COMMITTEE REPORT ON

WESTERN MILITARY FORTS

November 1965

REPORT OF COMMITTEE TO REVIEW WESTERN FORTS'
INTERPRETIVE DEVELOPMENT PROGRAMS

Drawing NHS-LAR 3124, Page 4, as well as other sheets of the plan, show it.

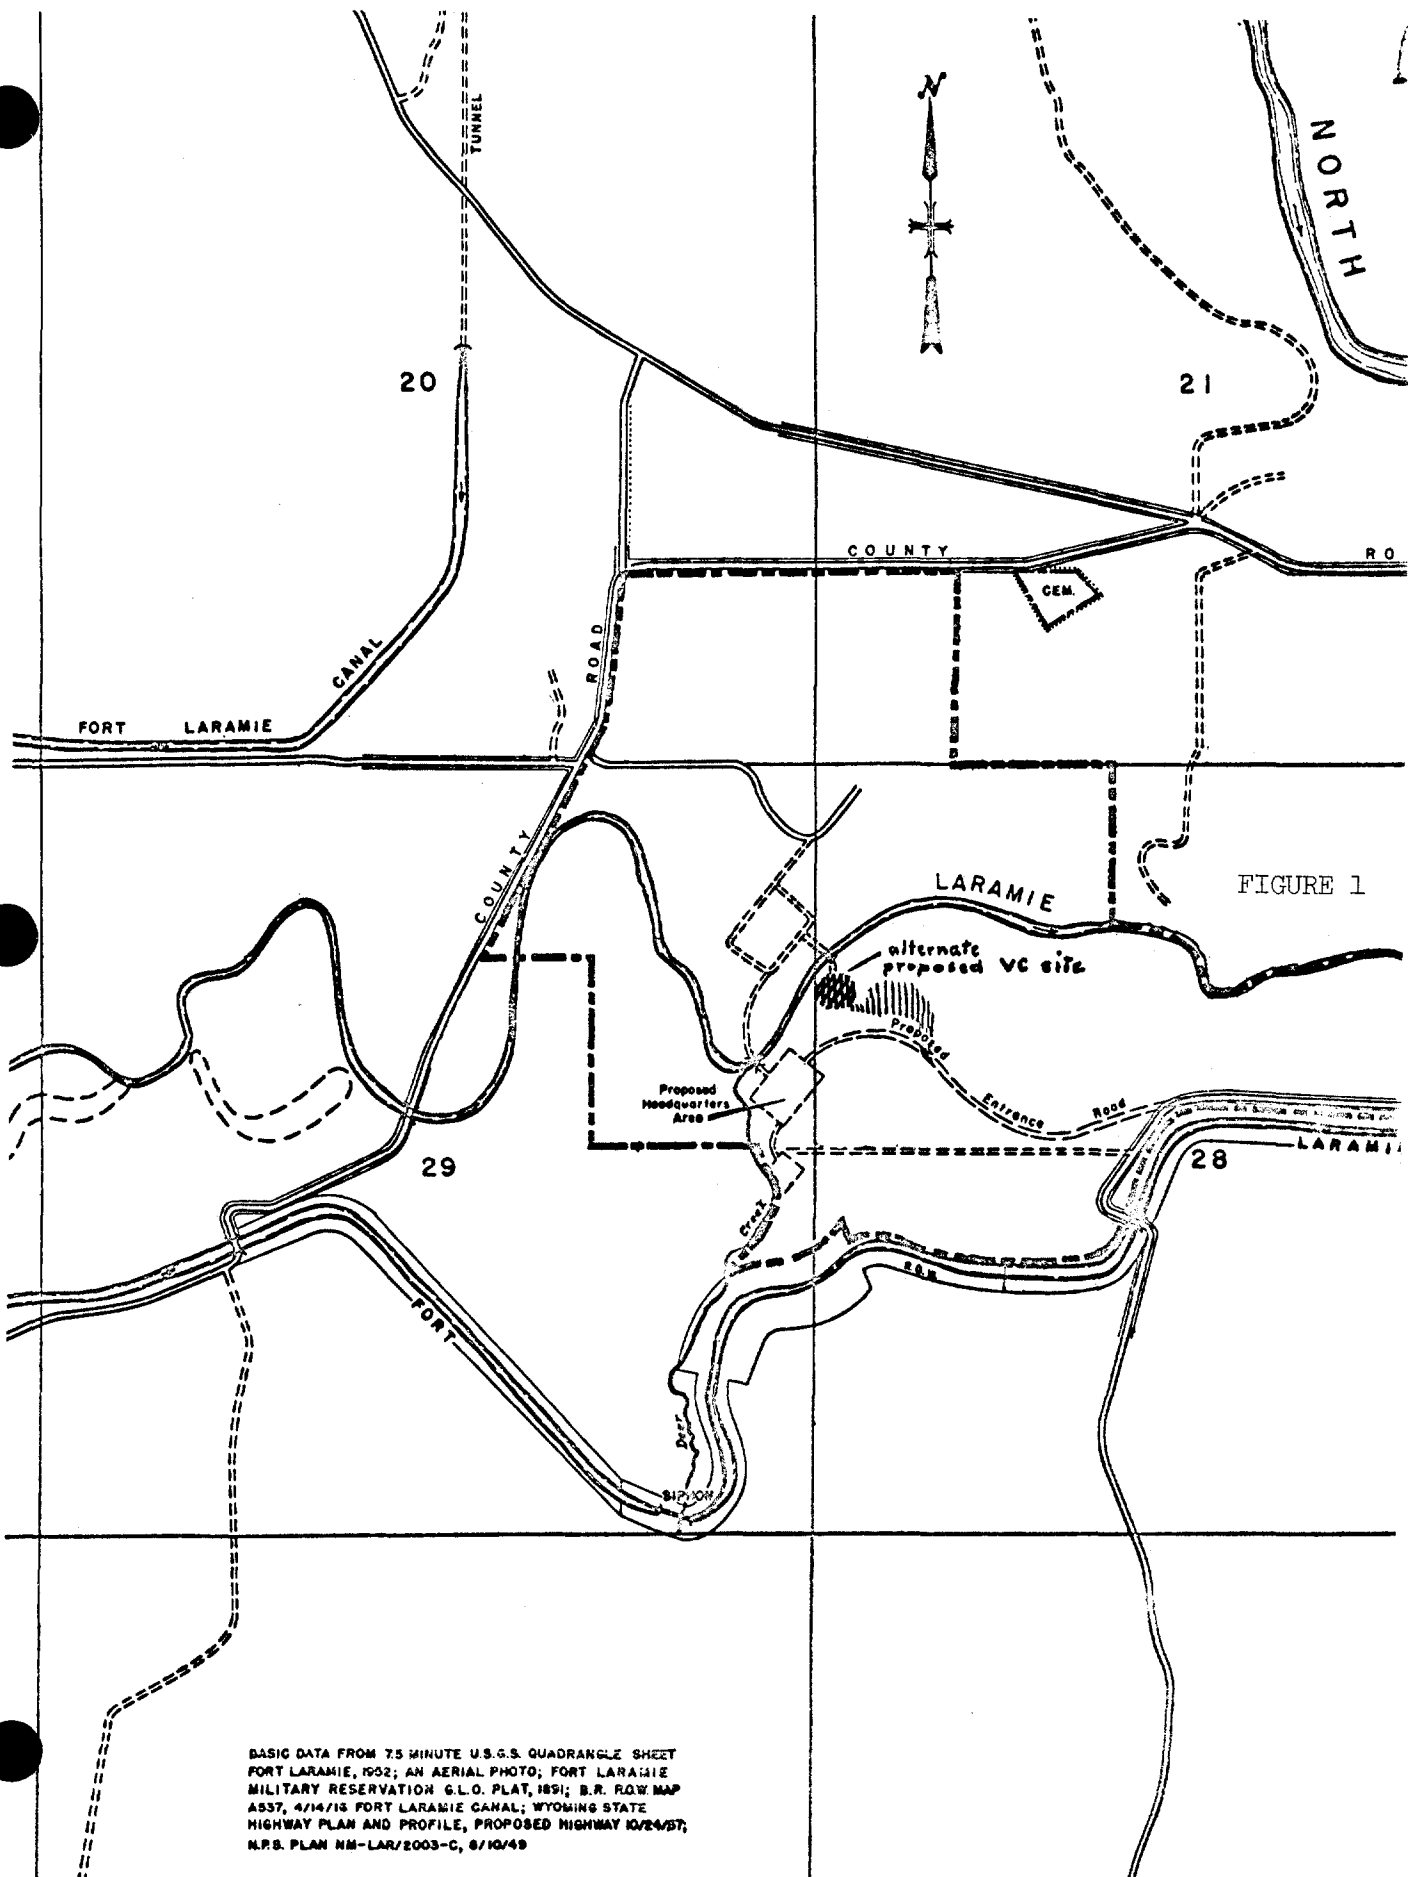
Committee members are unanimous in agreeing that to locate the visitor center, parking, maintenance, and residential areas where located on the present plan would be disastrously intrusive on the historic scene. Gregg, however, thinks skillful screening and architectural blending might reduce the intrusive character sufficiently to permit using this site. This location is the same in the 1965 resubmittal as in the earlier Master Plan.

In this case, the Committee feels that the Service itself would be responsible for the greatest intrusions in the historic scene that could be devised, outside of the main fort area, and be guilty of a desecration that it generally so strongly denounces. All, or nearly all, of the above proposed developments would be in the open and plainly seen from the fort and visitor use area across the Laramie River. Where there is now a natural unspoiled western landscape, in a full 360-degree circle as seen from the main fort area, there would be unsightly intrusions tantamount to a small modern village in the most prominent segment of that circle (Gregg thinks intrusive features might be minimized). The parking area alone is planned for 250 cars. A location for these features that would not be visible from the fort area should be sought.

After agreeing that the present locations for the visitor center and the above mentioned facilities seem inappropriate, the Committee members were unable to agree upon suitable locations for them. Wagers and Bierly agreed on one proposal, Gregg favored another solution, and Appleman still another. The essential features of these will be set forth below.

PROPOSED VISITOR CENTER FOR FORT LARAMIE

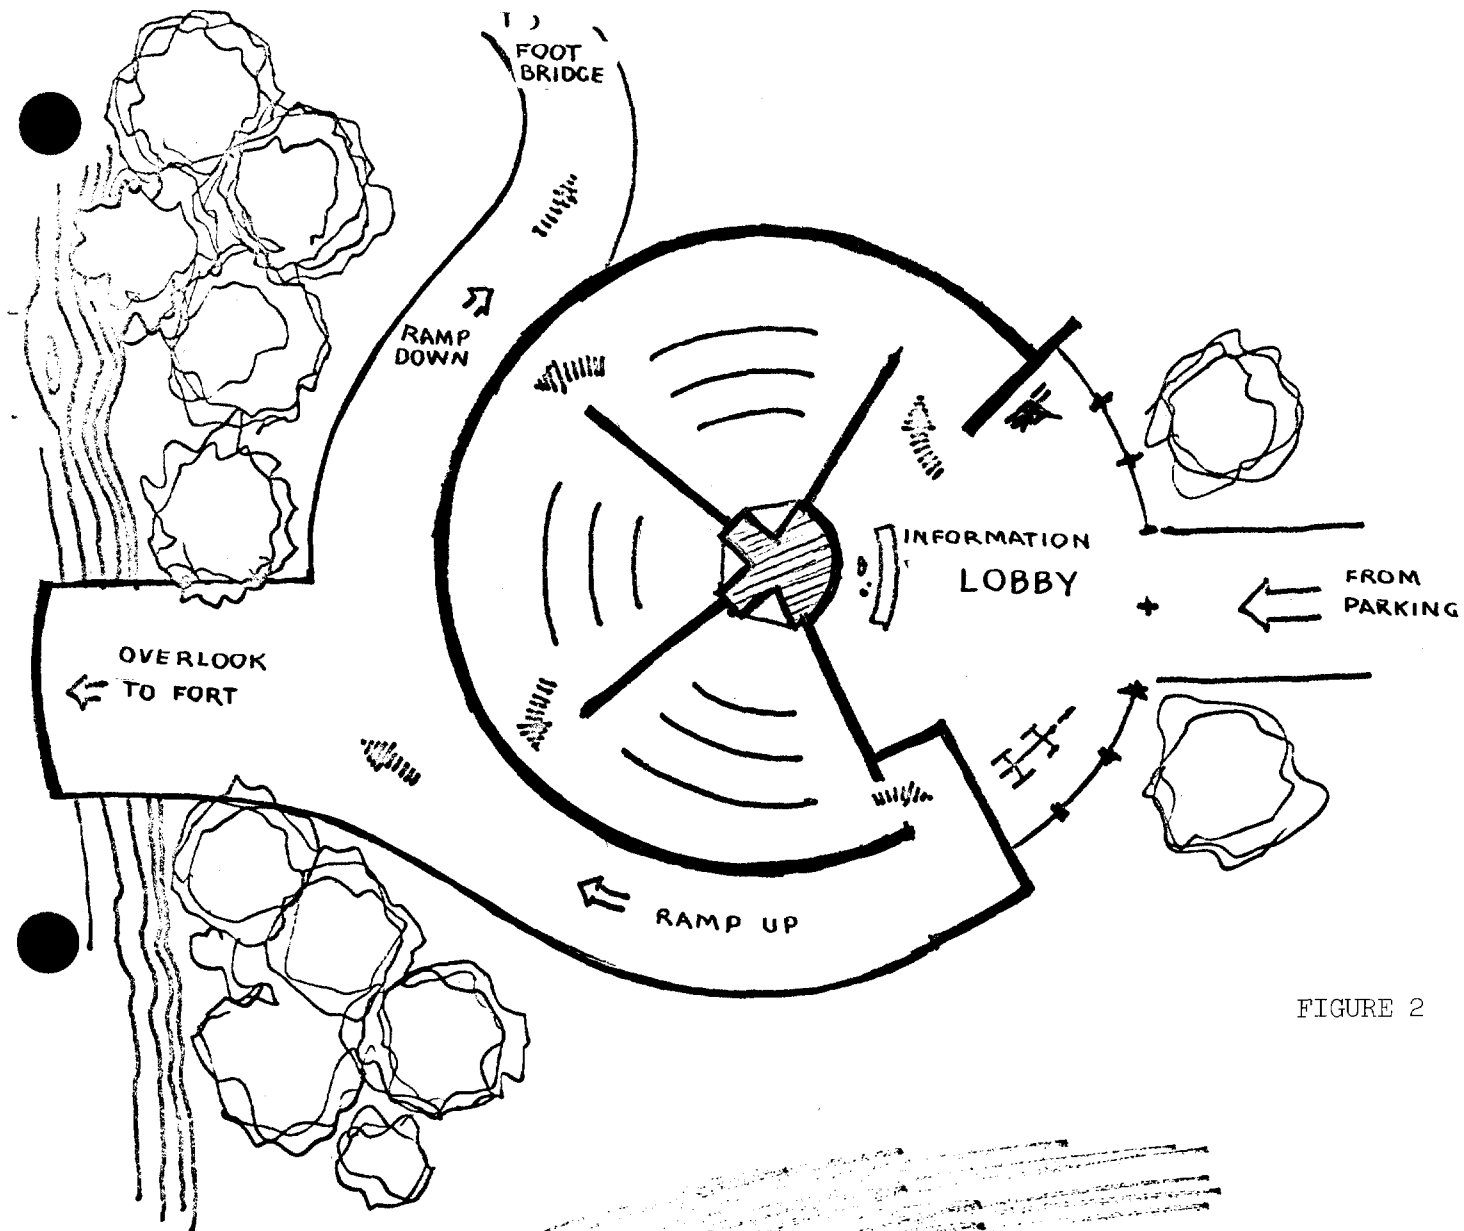
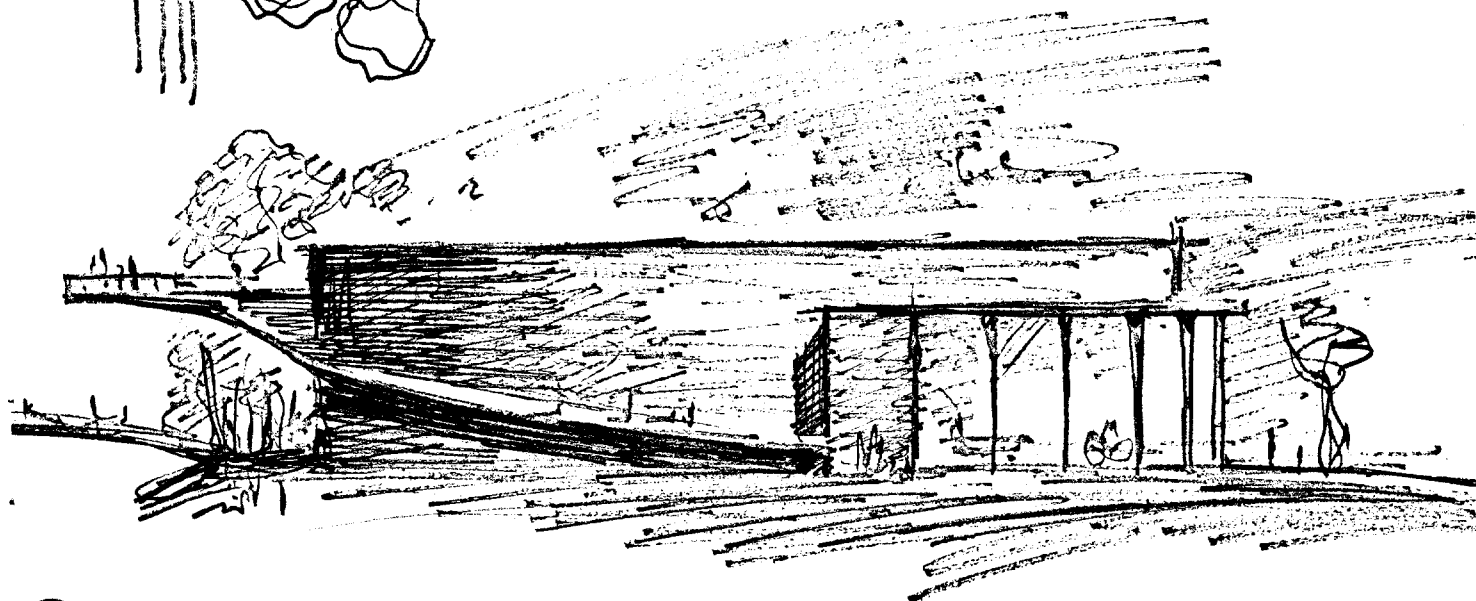
The presently proposed site, while offering a good view of the fort, in turn offers from some of the most critical viewing angles within the fort an imposing view of itself. Without debating the philosophy of a modern building as a backdrop to a restored fort scene, we suggest that by shifting the site about 250 yards to the east, one gains: (1) closer access to the fort; (2) a natural screen of cottonwoods along the river and a lower (but not on a flood plain) site; (3) a more accessible water table; (4) the element of surprise in presenting the fort (plan accompanies discussion in main section).

Housing or maintenance complex should not be built on the southern bank either in conjunction with visitor center or separately. If the function of either is protection, quick access to the fort is required, which means a vehicular bridge. The Committee could see

GREGG PLAN - FORT LARAMIE

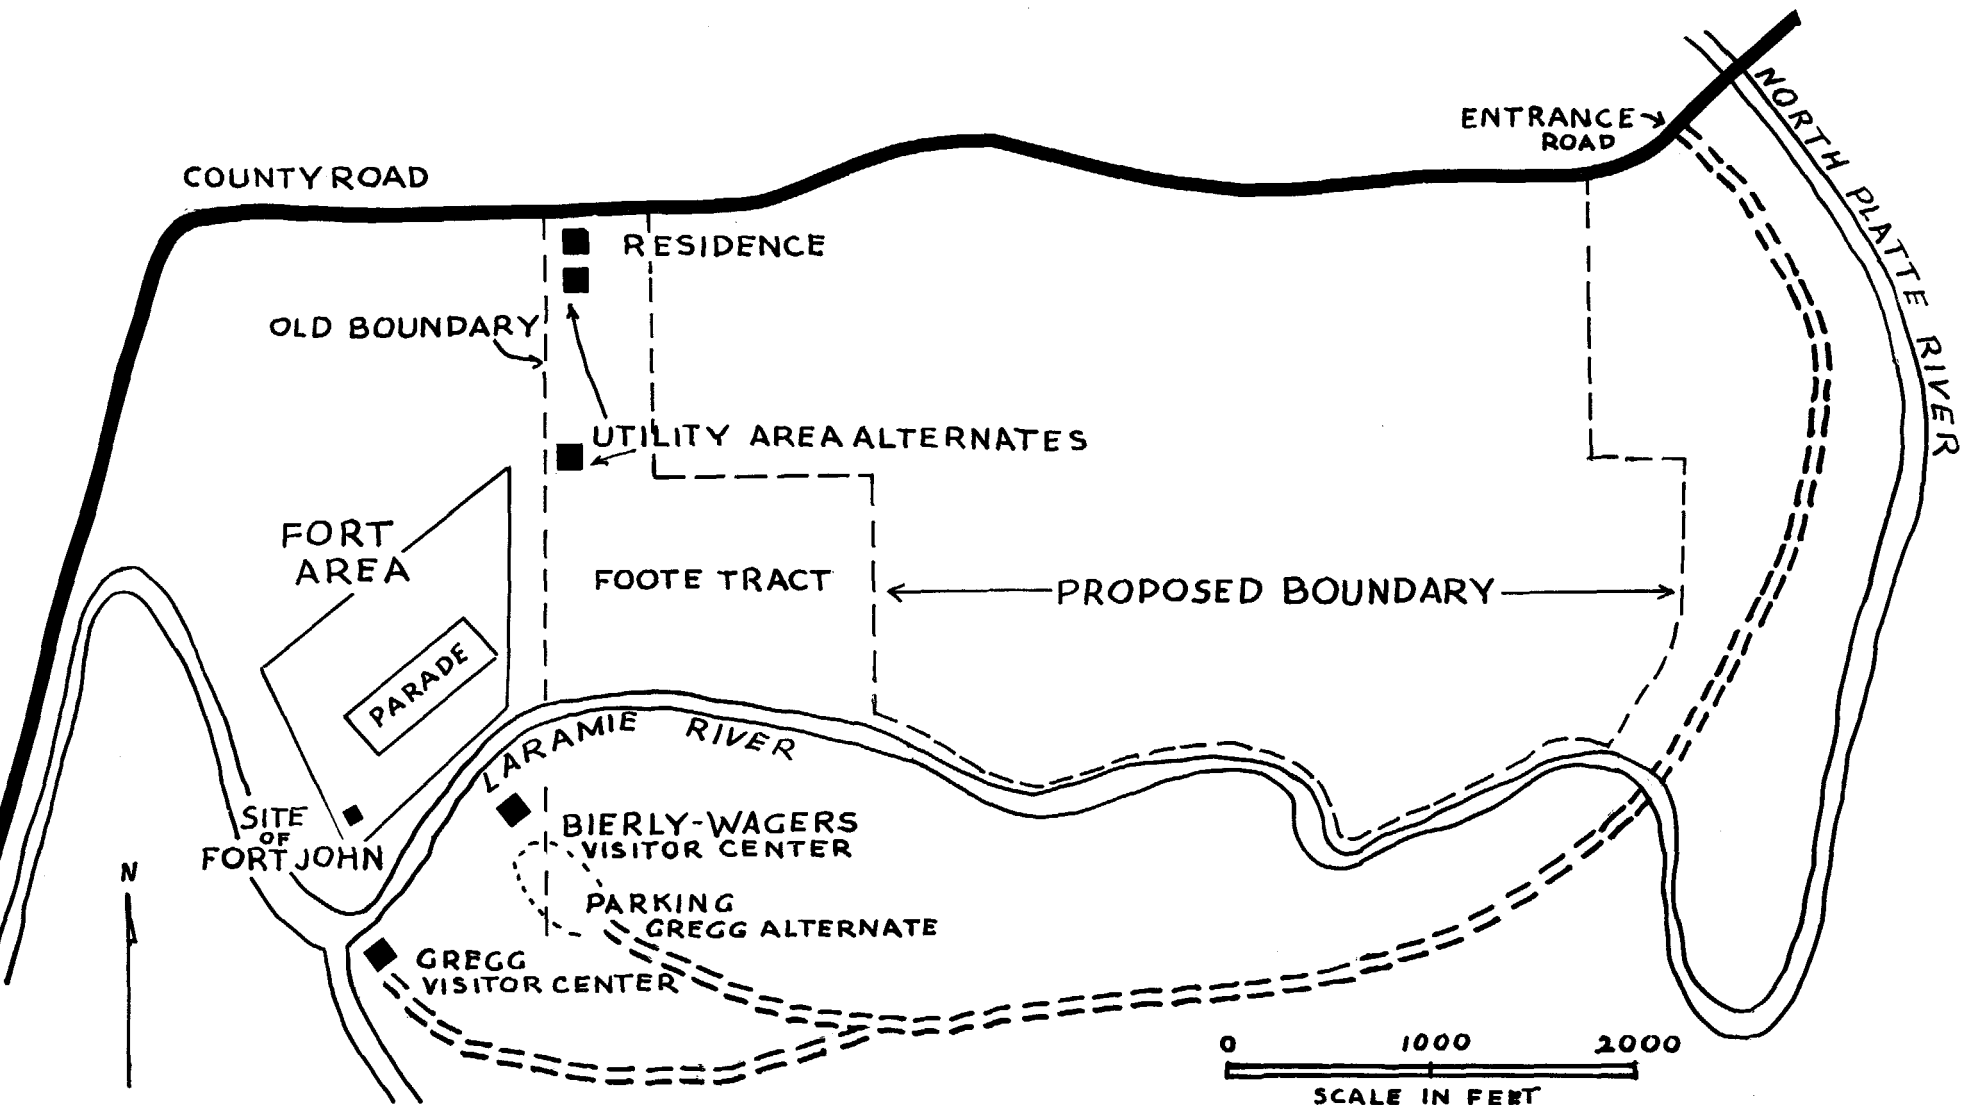
Location of the visitor center is the problem. Wagers, Bierly, and I all concur it should be south of the river, and the Master Plan road approach retained. I would prefer to see the location

remain essentially as planned, on the Ward-Guerrier Trading Post site, across from the southeast corner of the parade ground, but I would go along peaceably with a location opposite the Common Sink site as proposed by Wagers and Bearly, if it can be developed without encroaching upon or effacing the preserved foundations of "Suds Row", although I would hardly recommend an entrance into the fort via the common sink. In either case, access from the visitor center to the fort grounds would require a pedestrian bridge across the river.

APPLEMAN PLAN-FORT LARAMIE

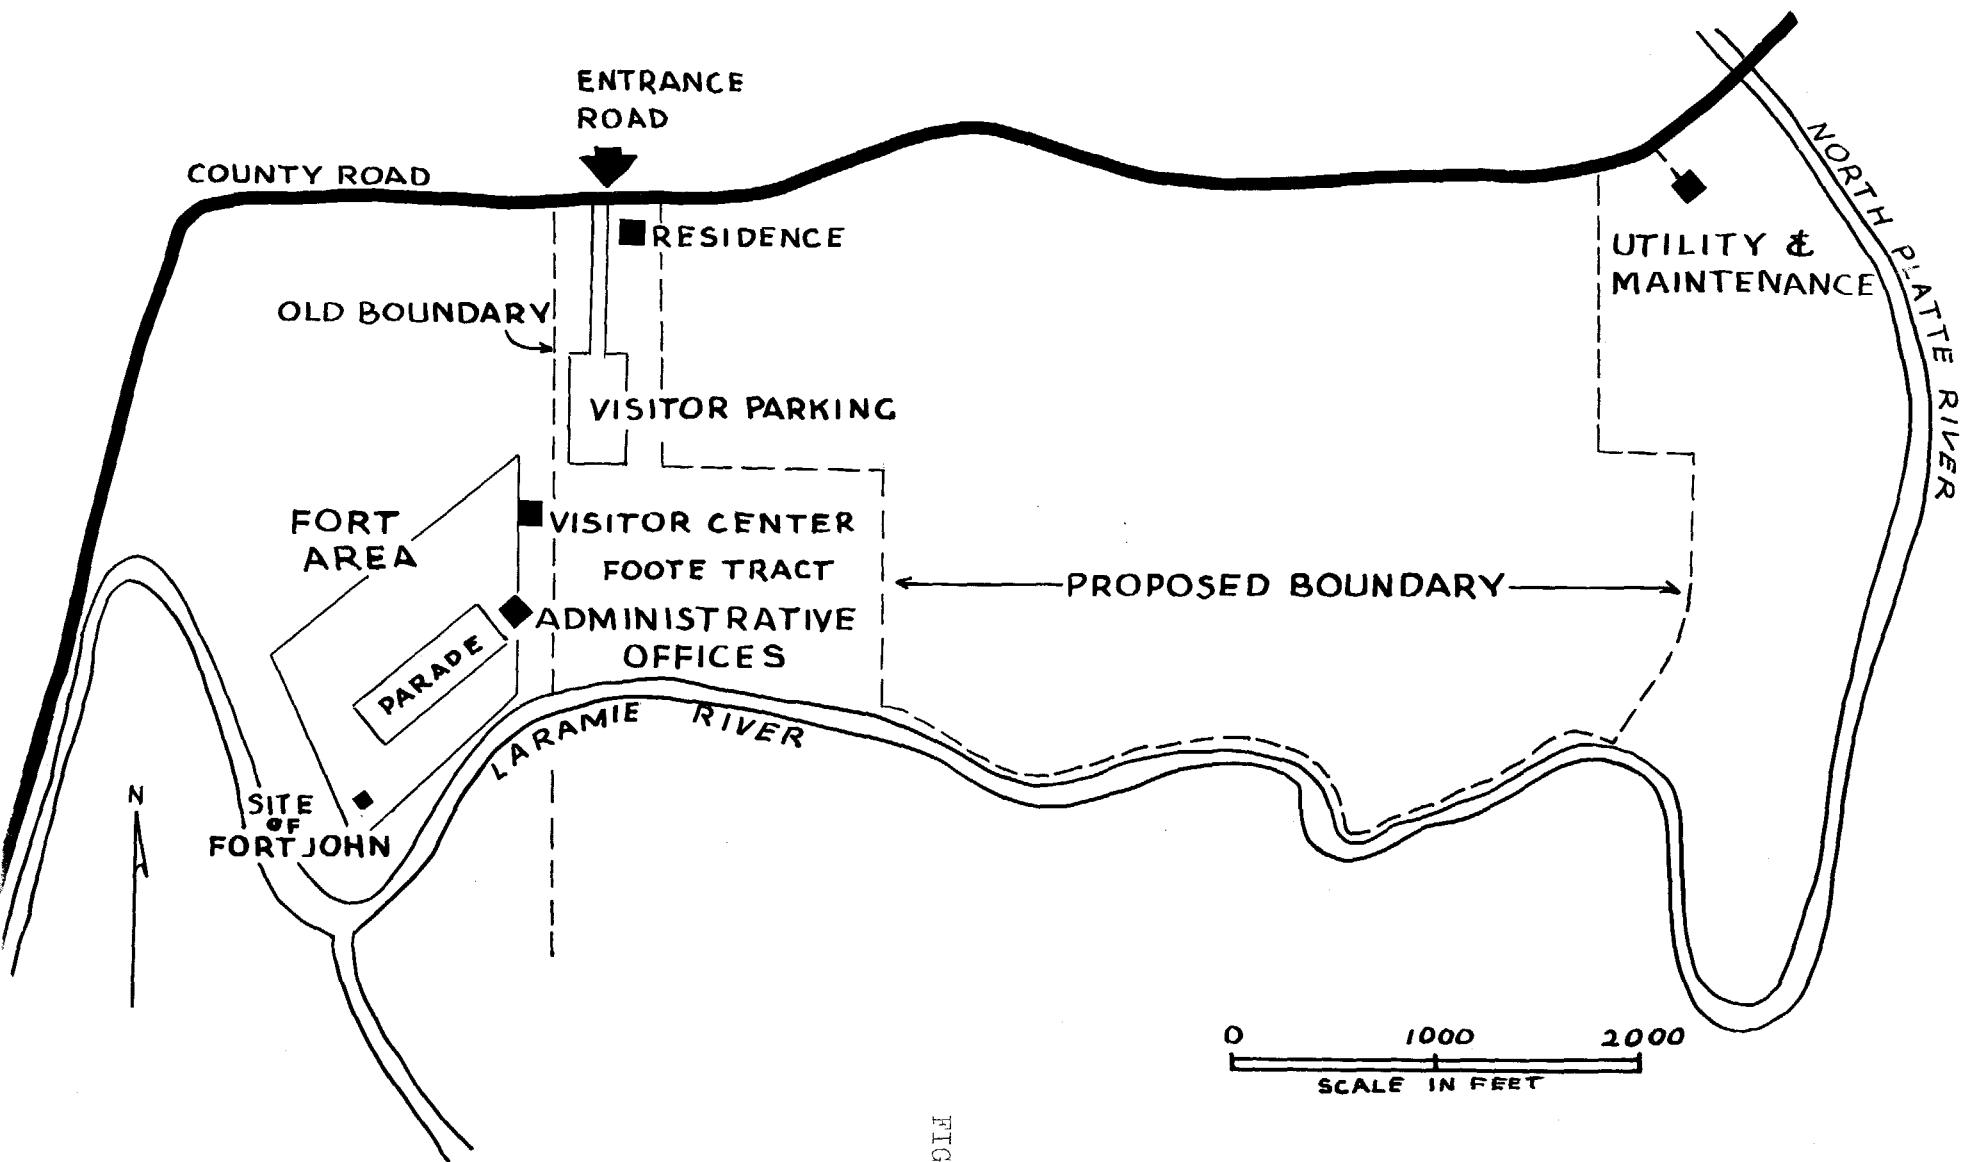
Minority View of General Development--Appleman: A brief

comment representing Appleman's views on location of the visitor center appeared above. Because his concept encompasses the location of all administrative, visitor use, and maintenance features north of the Laramie River, he withheld full comment until these features had been discussed above. His views follow: My views on the most desirable, practical, and economical development of Fort Laramie, and at the same time the most convenient for visitor use, have changed little over the years. These views were held and expressed prior to the 1960 legislation which authorized changing the boundaries of the fort area.

I am aware that the basic reason for the Service seeking, and eventually obtaining, the 1960 legislation was to acquire the land necessary to allow a visitor center and related facilities development south of the Laramie River where it is presently shown on plan. The legislation itself, Act of April 29, 1960 (74 Stat. 83), does not make any reference to this but confines itself to a description of the new boundary to be authorized and gives the reason as "in order to preserve the sites of historic buildings and roads associated with Fort Laramie,...". The House Hearings, Report No. 1432, 86th Congress, 2nd Session, identical Senate Bill 2434, however, does mention as a reason, "to provide space for an improved entrance road and headquarters development."

The question arises, with this background of Service planning in the late 1950's which resulted in the Service seeking and obtaining legislation looking toward placing the main visitor services facilities on the south side of the Laramie River, is there freedom of action now to consider changing this planning. I will not presume to answer this question, but can only give my opinion.
